HOMELAND ACRES
FINAL PLAT

LOCATED IN PORTION OF SECTION 4,
TOWNSHIP 16 SOUTH, RANGE 65 WEST, OF THE 6TH P.M.,
THE CITY OF FOUNTAIN, EL PASO COUNTY COUNTY, STATE OF COLORADO
SHEET 1 OF 2

FILE NO. SF2416

FINAL PLAT COVER

LOCATION MAP
NOT TO SCALE

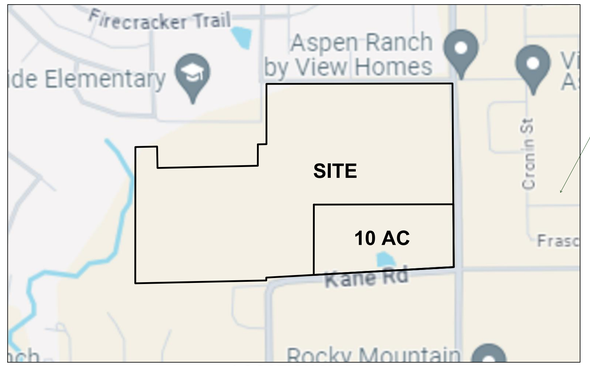
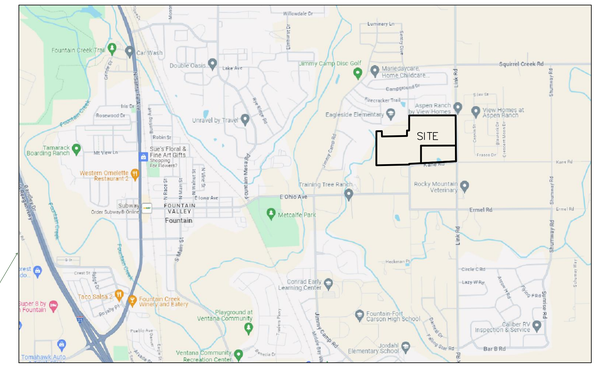
These maps are missing north arrows
